Access Compliance Report

Public Rights-of-Way

(Curb Ramps)

Intersection ID: N/A	Main Street: S_DAVIDSON_ST	Cross Street: N/A	Location: W
ADA ID: E3DDAD8A8C6F	Ramp Type: Perp	Initial Pass/Fail: Fail	Overall Compliance: No
		Severity Score: 25

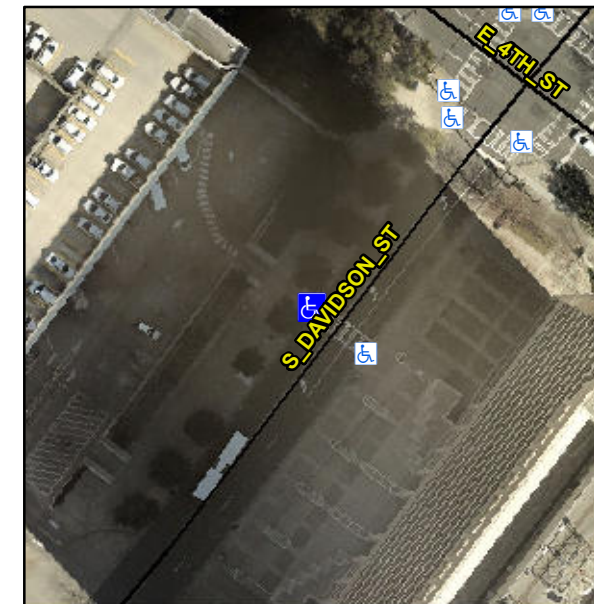
Not Found, R304.2.2, R304.5.3

Compliance	Description	Data	Compliance	Description	Data
N/A	Ramp Length (in)	71.5	No	Ramp Slope (%)	10.7
Yes	Ramp Width (in)	96.0	No	Ramp XSlope (%)	5.5
N/A	Flare Type LT	N/A	N/A	Flare Type RT	N/A
N/A	Flare Slope LT (%)	N/A	N/A	Flare Slope RT (%)	N/A
N/A	Flare Traversable LT?	No	N/A	Flare Traversable RT?	No
N/A	Landing Length (in)	N/A	N/A	DWS Provided?	N/A
N/A	Landing Width (in)	N/A	N/A	DWS Contrast?	N/A
N/A	Landing Slope (%)	N/A	N/A	DWS Length (in)	N/A
N/A	Landing X Slope (%)	N/A	N/A	DWS Full Width?	N/A
N/A	Landing Curb? (Y/N)	N/A	N/A	DWS Offset (in)	N/A
N/A	Shared Landing?	N/A			
N/A	Gutter Ponding?	N/A	N/A	Gutter Slope (%)	N/A
N/A	Gutter Lip Ht (in)	N/A	N/A	Gutter X Slope (%)	N/A
N/A	Painted X Walk1?	Yes	N/A	Painted X Walk2?	N/A
	X Walk 1 Direction	To SE		X Walk 2 Direction	N/A
N/A	X Walk 1 Width (in)	111.0	N/A	X Walk 2 Width (in)	N/A
	X Walk 1 Slope (%)	3.3		X Walk 2 Slope (%)	N/A
	X Walk 1 X Slope (%)	5.8		X Walk 2 X Slope (%)	N/A

Remove & Replace Entire Ramp.
